[Docket No. FAA-2012-0415; Directorate Identifier 2008-SW-065-AD; Amendment 39-17865; AD 2014-12-04]

Airworthiness Directives; Bell Helicopter Textron, Inc. (BHTI) Helicopters

ACTION: Final rule.

Figure 1 to Paragraphs (f)(2)(ii) and (f)(4)(ii)
Inspection of Main Rotor Hub Grip Tangs

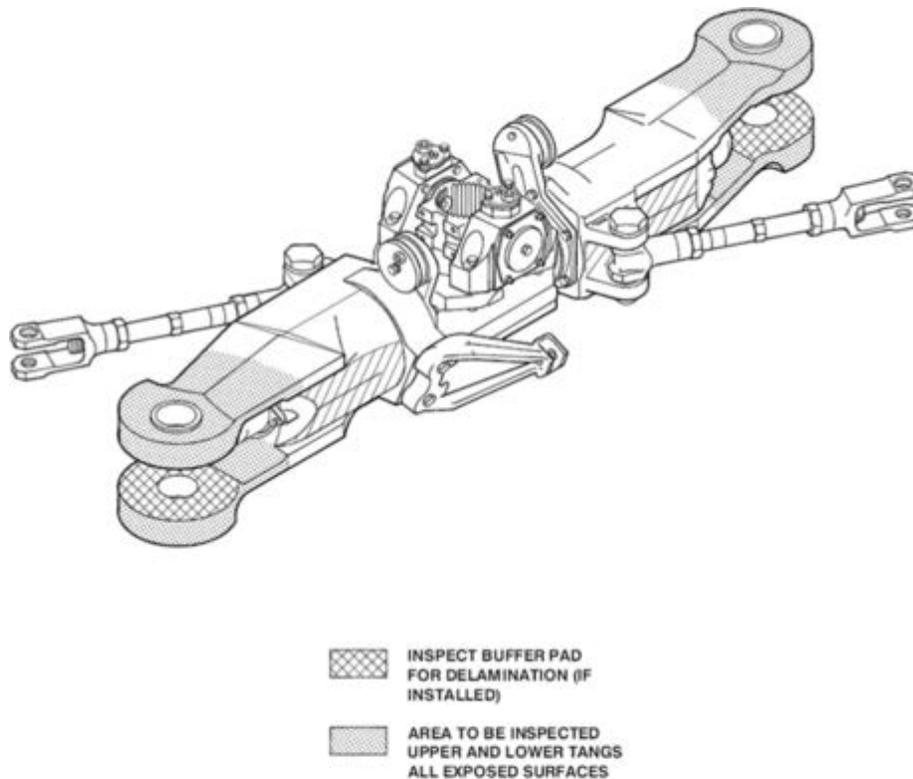
(ii) Using a 10-power or higher magnifying glass, visually inspect the exposed surfaces of the upper and lower tangs of each grip for a crack. Pay particular attention to the lower surface of each lower grip tang from the main rotor blade bolt-bushing flange to the leading and trailing edge of each grip tang as depicted in Figure 1 to Paragraphs (f)(2)(ii) and (f)(4)(ii) of this AD.

- (i) Remove each main rotor blade, and
- (ii) Inspect each grip buffer pad on the inner surfaces of each grip tang for delamination as depicted in Figure 1 to Paragraphs (f)(2)(ii) and (f)(4)(ii) of this AD. If there is any delamination, remove the buffer pad and inspect the grip surface for corrosion or other damage.
